CITY OF WESTFIELD, IN

Advisory Planning Commission Meeting Agenda

MEETING DATE: Tuesday, February 17, 2026 at 7:00 PM

Petition Number: 2512-DDP-39
Project Name: Gateway at Lantern Commons
Subject Site Address: 16170 John Burtwell Dr.
Petitioner: MB Lantern, LLC
Representative: Terra Site Development
Request: Detailed Development Plan review of a mixed-use residential development on 4.71 acres +/- in the Lantern Commons PUD District.
Current Zoning: Lantern Commons PUD
Current Land Use: Vacant
Approximate Acreage: 4.71 acres +/-
Exhibits:
1. Staff Report
2. Location Map
3. Site Plan
4. Elevations
5. Landscape Plan
Staff Reviewer: Lauren Gillingham-Teague, AICP – Senior Planner

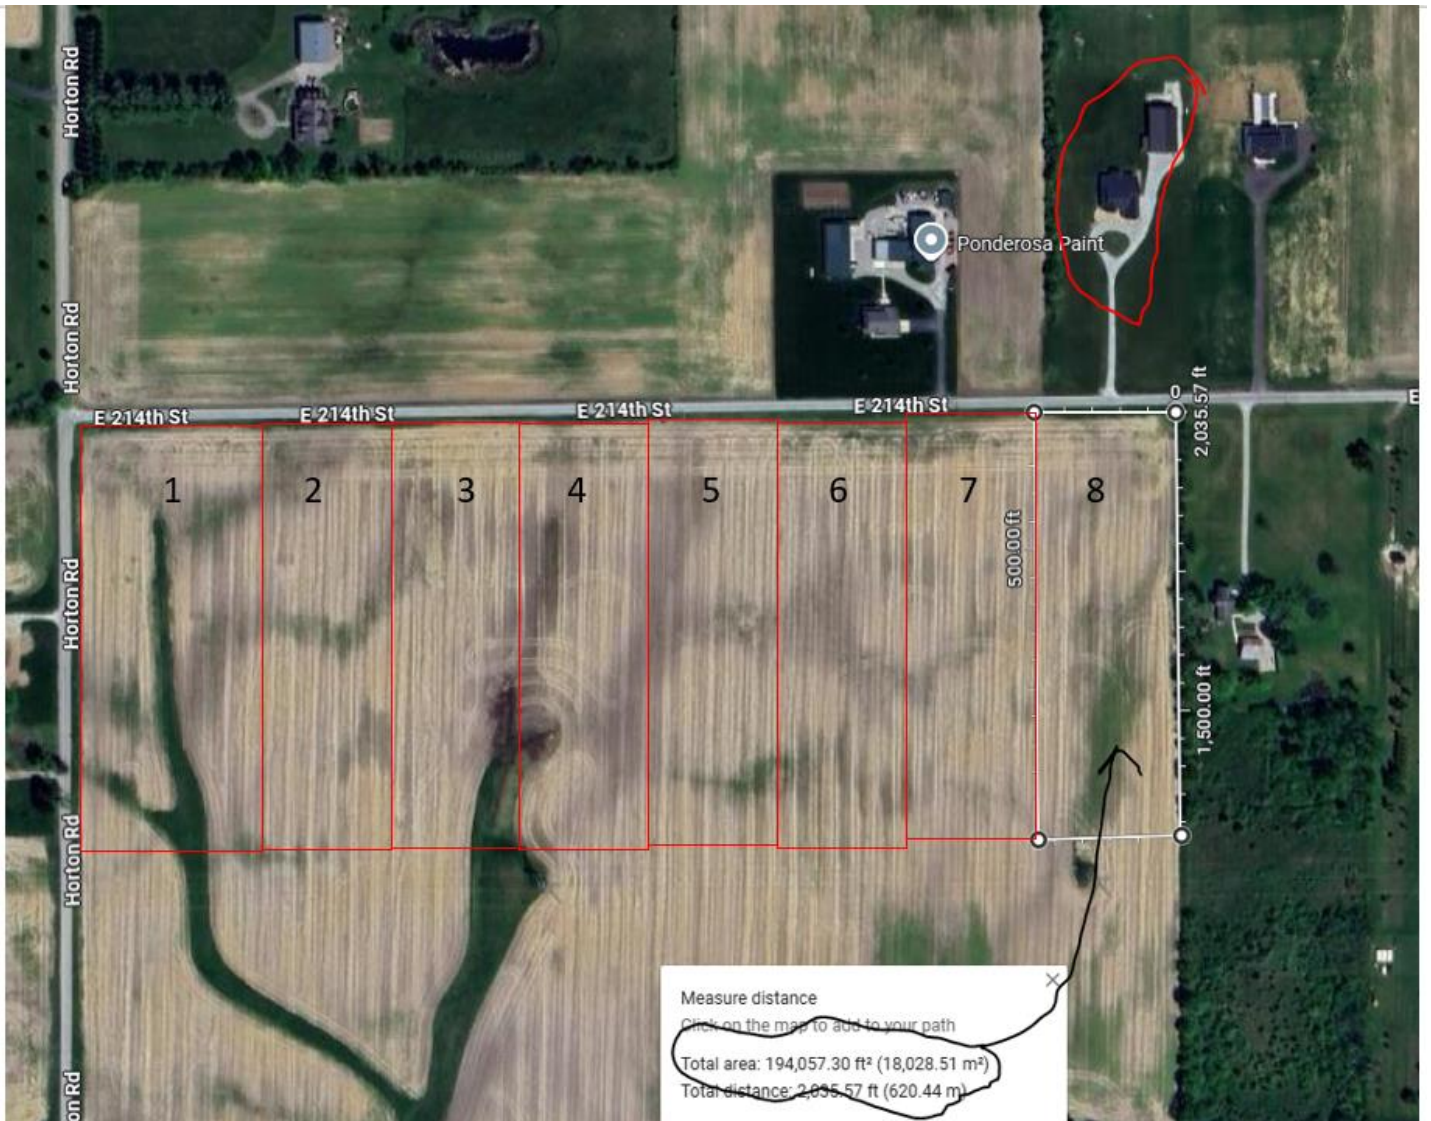
Please refer back to this screen shot below throughout this letter.

- Other than Chatham Hills and a few smaller neighborhoods, pretty much everything North of 32 is medium / high density housing and apartments. These will all become eye sores eventually, if not already, as properties pass to the 2nd, 3rd, 4th owners. We do not need any more of this type of housing at the moment. The growth is out of control and there will be considerable pain for residents if this irresponsible trend continues.
- WHO ARE THE WINNERS? I'd really like to know who is winning by having 2200 more homes crammed into our community and school system? Some out of town developer? It certainly isn't the citizens.
- Please tell me how this benefits the current citizens?

- Does the school board have anything to say about this? How many letters has Dr. Atha and the principles received about parents angry that their child is in a temporary classroom (I was one of them)? I realize that the developer has included a "donation" for additional school land, but perhaps we wouldn't even need it if we just STOPPED BUILDING ALL of these high density neighborhoods.

214th Street Buffer

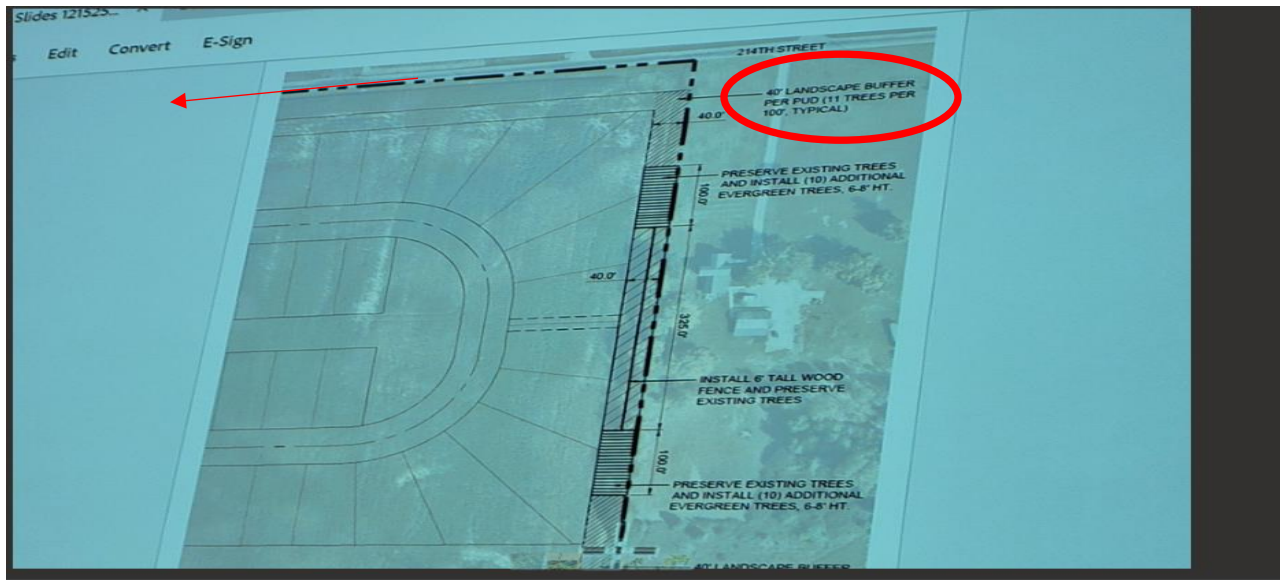
Looking at an image of the slide created to describe improvements being made to the border with the Barrett property, I'd like to know what the proposed landscape buffer is along 214th street? Is it a mound all the way down the road, trees, mound and trees? Would this be HOA maintained or privately? What will protect my property from noise and light pollution? Revert back to the street view of what is there now, it's flat and peaceful. You can imagine the distaste that residents on the entire street has for this happening.

5. Request for Detailed Landscape and Buffer Drawings

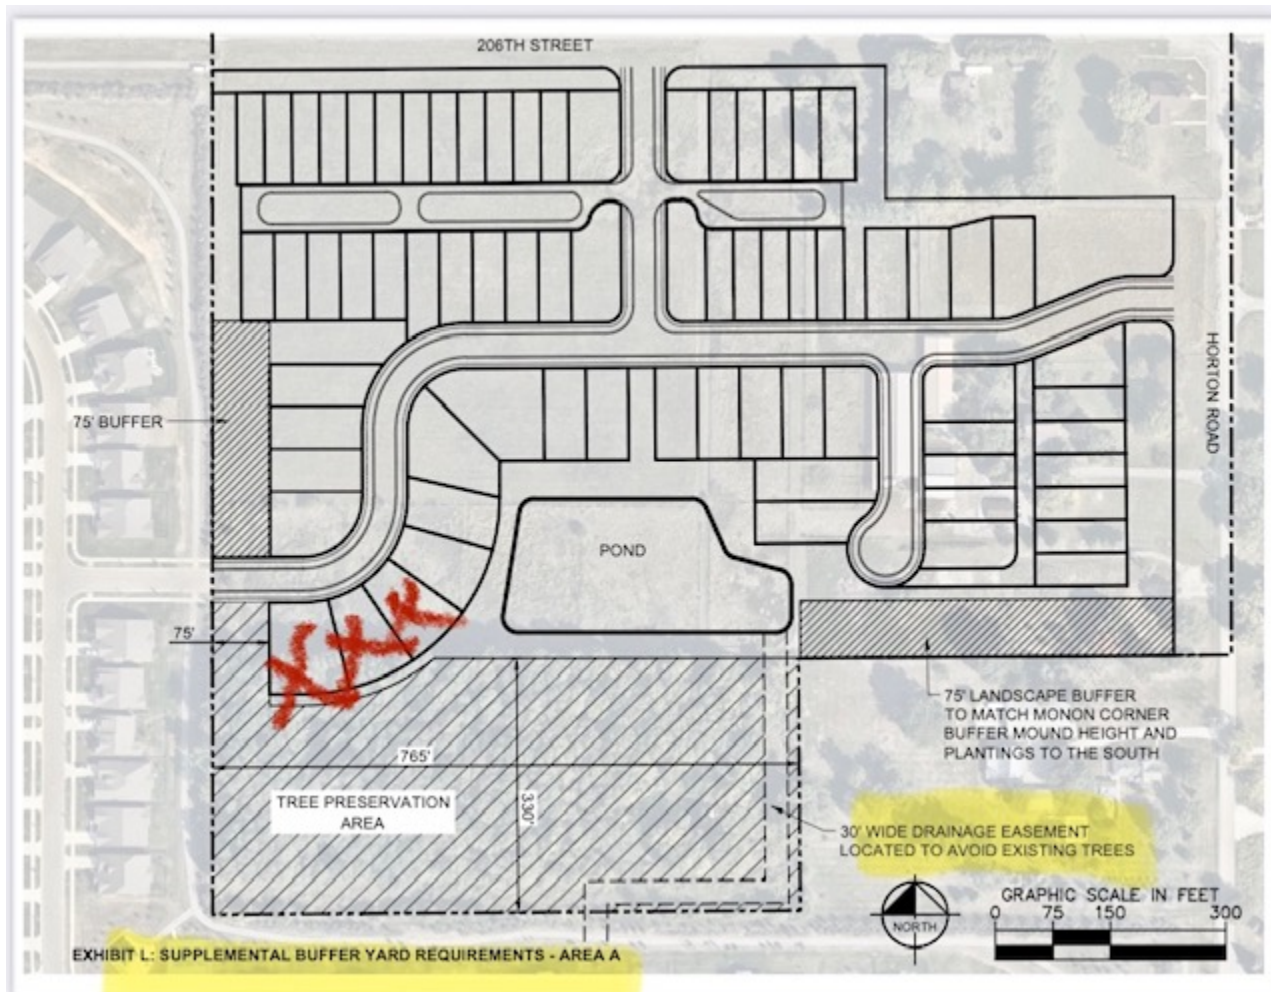
For the January 20th workshop, we respectfully request a detailed landscape plan for all proposed buffers. Specifically, we would like to understand the exact placement, height, and design of any mounds. We are concerned about potential water runoff if a mound is placed too close to our property, which could result in standing water.

We have previously experienced runoff and standing water issues from the south mound adjacent to our property, which required Arbor to make several adjustments. Given that history, it is important for us to review detailed plans in advance to ensure similar issues are not created along the west or north buffers.

Additionally, we note that the bottom of the drawing references **“Exhibit L: Area A,”** but no further information or explanation is provided. We respectfully request clarification regarding what this exhibit represents and how it applies to the overall plan.
